22 September 2021

RESPONSE TO SUBMISSIONS UNSW HEALTH TRANSLATION HUB (SSD-10822510)

Figure 1 Previous Residential (now removed) tree canopy (left) and proposed tree canopy (right)

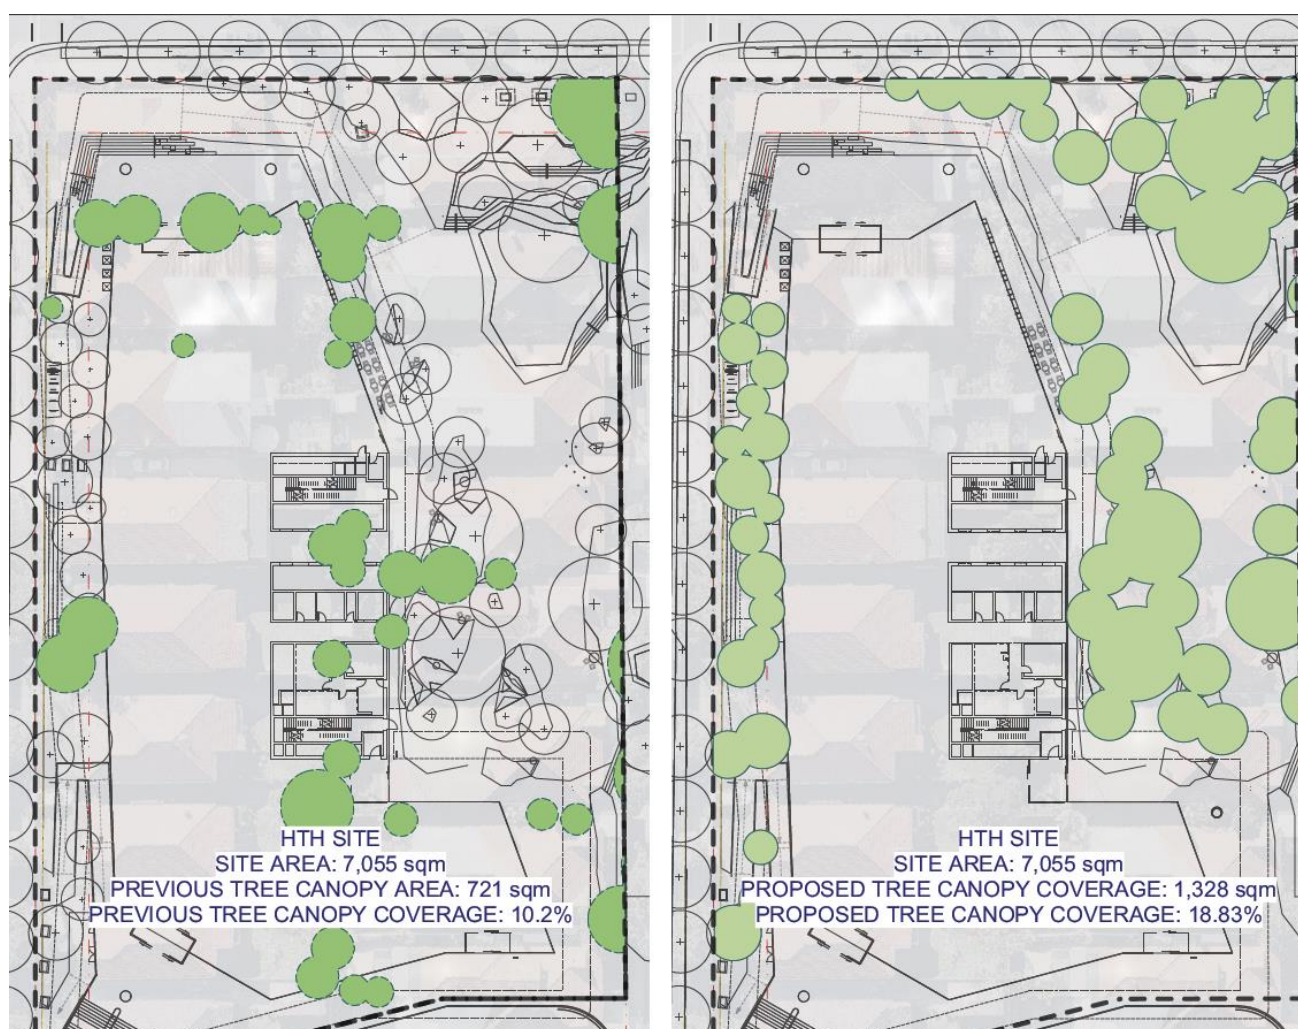
DPIE and Council have suggested that consideration be given to improving canopy cover, noting that the proposed 14% coverage is less than the minimum 25% recommended by the NSW Government Architect's Draft Greener Places Design Guide.

In response to the submissions, further consideration has been given to tree plantings and tree canopy coverage on the site. The proposed tree canopy coverage has been increased to 18.83%, which is more consistent with the recommendations of the Draft Greener Places Design Guide.

The revised proposal represents an increase of 4.83% when compared to what was originally proposed, and an increase of 8.63% when compared to the previous residential tree canopy cover (now removed). This has been achieved through planting of additional trees and greater consideration to species selection which has resulted in larger tree canopies. A comparison between the previous residential tree canopy (now removed) and proposed tree canopy cover is provided at **Figure 1**. **Figure 2** provides further detail around tree canopy plantings both within the site, and on the surrounding footpath. Additional trees have been located where soil depth is appropriate, particularly within the northern landscape embankment and the plaza planters. Tree planting within the stormwater culvert has been restricted to areas which allow for substantial mounding, resulting in greater soil volume. Sections through the stormwater culvert, demonstrating that the soil depth is capable of accommodating significant tree plantings, are provided at **Attachment D**.

Figure 2 Proposed tree canopy coverage

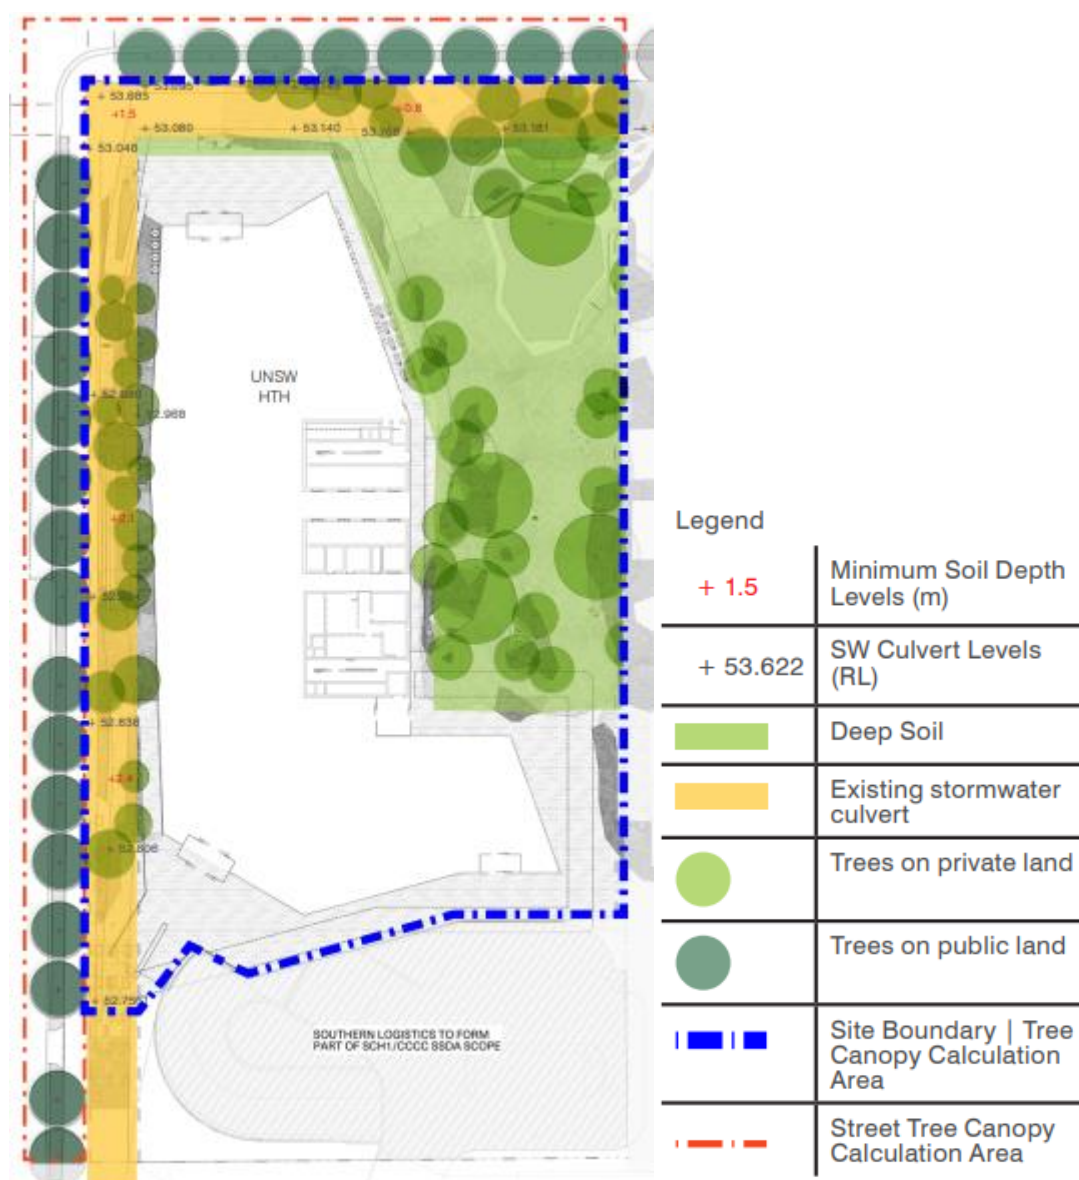
- Consideration to the provision of larger trees and more trees at the ground plane, particularly in the deep soil zones, but also through improved soil depth and volumes for on-structure plantings and through more detailed consideration of opportunities and limitations of plantings above and around the stormwater culvert.
- Consideration to providing plantings to upper-level terraces and utilisation of podium roof areas for landscaping to provide high quality outdoor spaces for occupants of the building and to assist with offsetting any shortfall in tree canopy cover.
- The landscape plans are to be updated to provide additional detail including: the species of each tree, a planting schedule that identifies species, pot size and the mature height and width of trees, soil depth over the stormwater culvert, and the provision and specifications of any permeable paving.
